Service Bulletin #: SB 22

Title: Cirrus SIU Filter Kit

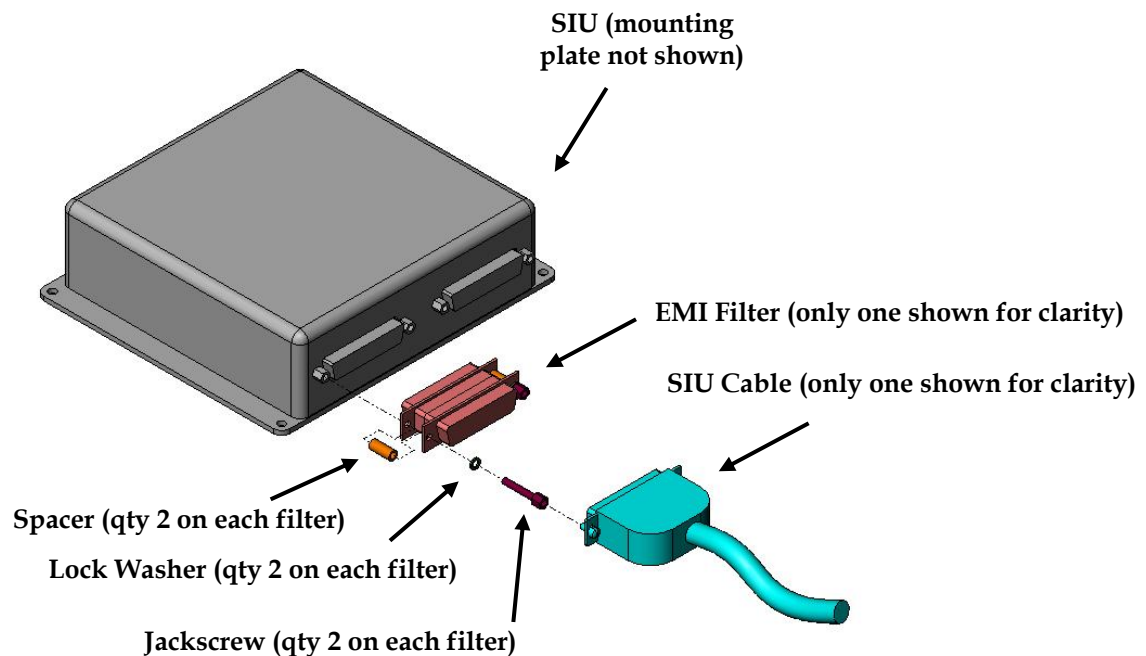
This Service Bulletin describes the installation of an EMI noise filter between each of the two SIU cable connectors and the SIU itself. The filters and the accompanying fastener hardware are contained in the Service Bulletin 22 Kit, Avidyne part number 850-00007-201.

1. \_\_\_\_\_ Drop the aluminum plate which holds the SIU. This is located under the copilot instrument panel. Refer to Cirrus Design Maintenance Manual Number 12137-001 (SR20) or 13773-001 (SR22) for exact location of the plate, if needed.
2. \_\_\_\_\_ Unscrew and remove the two cables attached to the SIU.
3. \_\_\_\_\_ Install a filter onto each connector on the SIU. Make sure to insert a spacer between the filter flanges on each side, and secure each filter with two jackscrews and lockwashers. Refer to the figure below:
